## CITY OF GLENDALE, CA

### DESIGN REVIEW STAFF REPORT – MULTI-FAMILY / MIXED USE

**1035 Raymond Avenue**

**PADR-004032-2024**

1 (N) SITE PLAN  
1/8" = 1'-0"

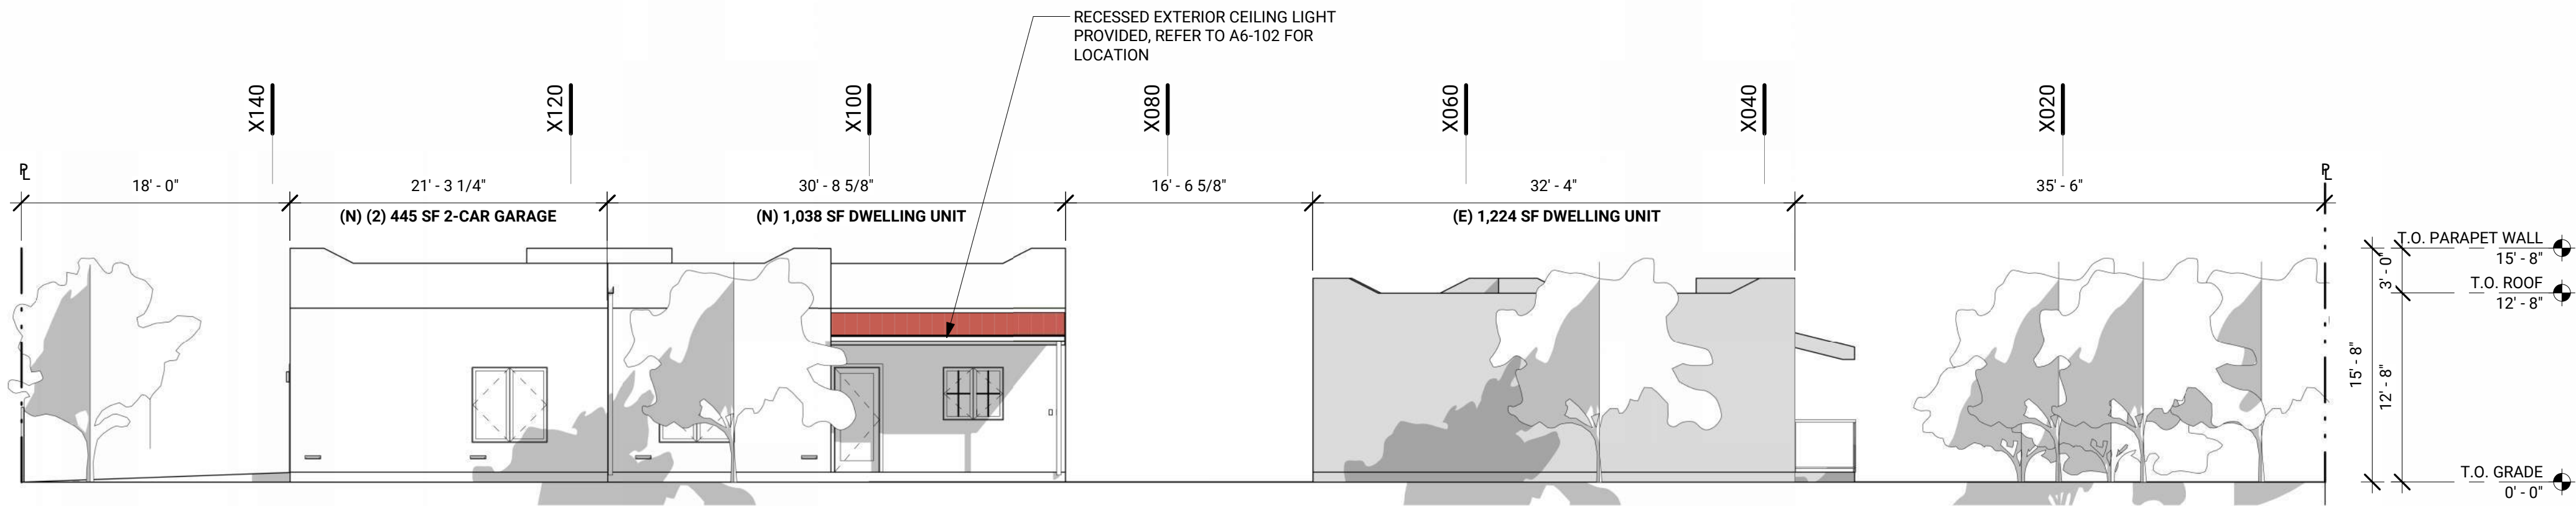
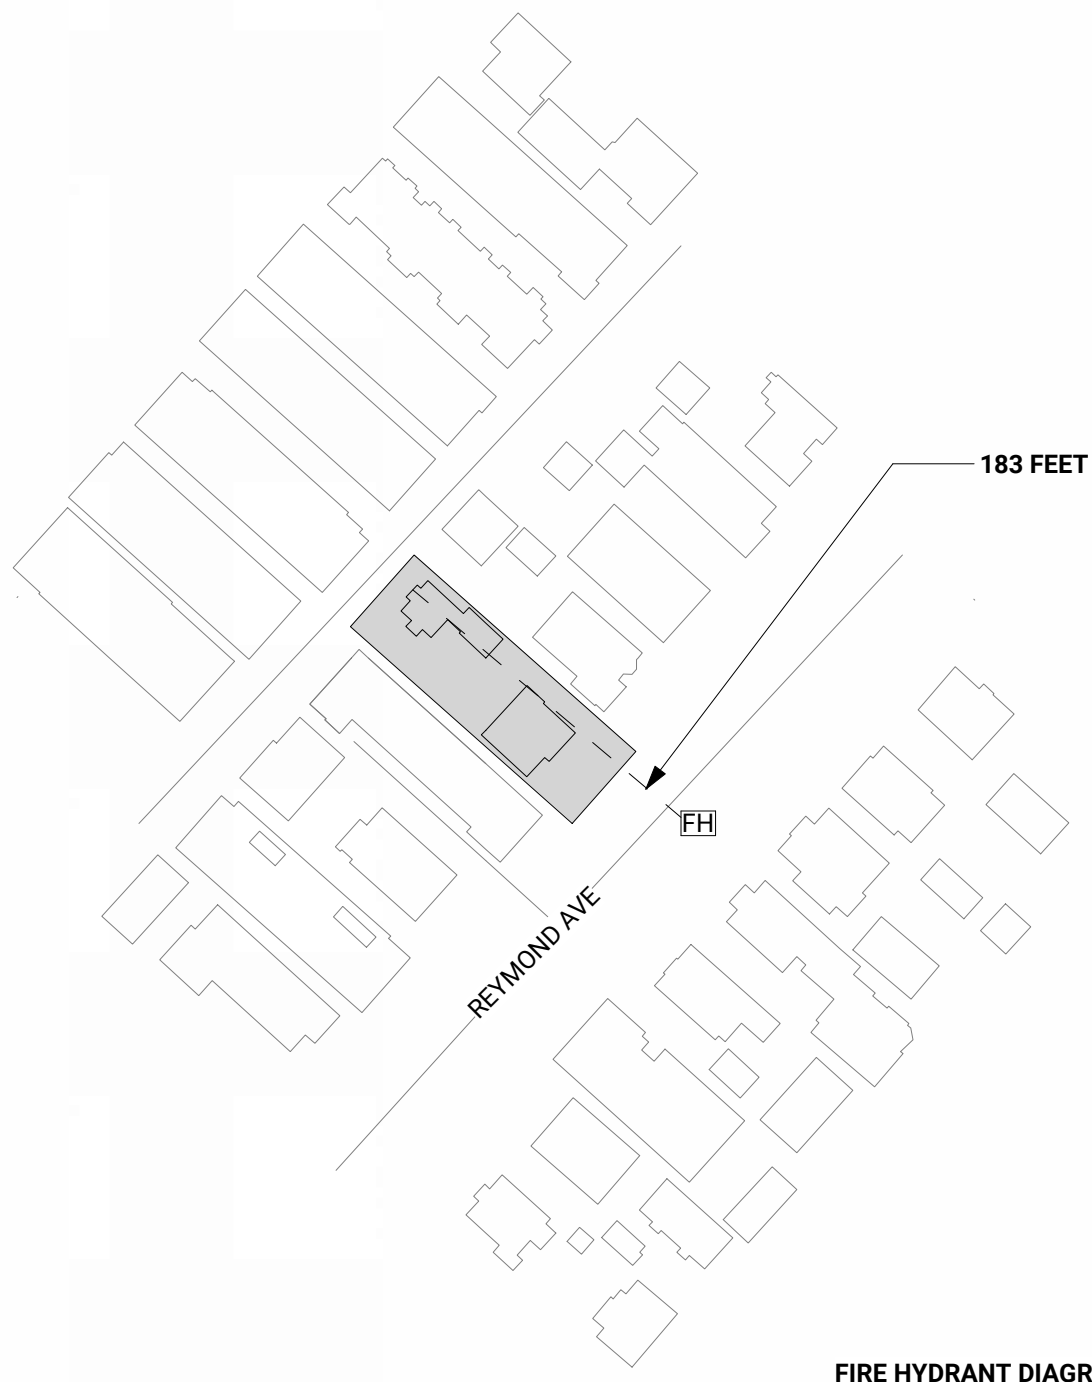
The proposed garages with access from the rear alley are well integrated into the overall design. The existing driveway off Raymond Avenue will no longer be used since the project is removing the existing detached garage with access from Raymond Avenue. A condition of approval is added to obtain the required permits from Public Works – Engineering Department to close the existing curb cut (driveway opening). The project’s plans shall be updated to show the removal of the existing driveway and driveway opening (apron/curb cut).

The project's plans indicate that most of the existing landscaping will remain unchanged. However, the plans do not indicate the new plant types and quantity. A condition of approval is added to update the proposed project's plans to incorporate a landscape plan to include new drought tolerant plants, complementary to the overall design. A condition of approval is also added to update plans to include the required street trees per Public Works – Urban Forestry requirements and obtain the required permits for the installation of two new street trees. The proposed site plan and landscape plan shall be updated to clearly show the required two (2) street trees.

A condition of approval is added to update the proposed project's plans to show the appropriate location of the trash bins/storages to be out of public view and out of the required setbacks.

- The project plans show the trash bins/storages within the new garages with the minimum interior dimensions of 20 feet by 20 feet. A condition of approval is added to update the proposed project's plans to relocate the trash bins/storages to an appropriate location, outside of the garages, out of public view, and out of the required setback areas.

1. Update the proposed project's plans to relocate the trash bins/storages to an appropriate location outside of the minimum required spaces within the new garages, out of public view, and out of the required setbacks.

2. Update the proposed project's plans to incorporate a landscape plan to include new drought tolerant plants, complementary to the overall design.
3. Obtain the required permits from Public Works – Engineering Department to close the existing curb cut (driveway opening) along the street.

4. Update the project plans to show the removal of the existing driveway and driveway opening (apron/curb cut). The existing driveway curb cut shall be closed prior to the Final Design Review Inspection.

5. Update the new site plan to clearly show the required two (2) street trees.
6. Obtain the required permit(s) from Public Works – Urban Forestry for the installation of two new street trees.
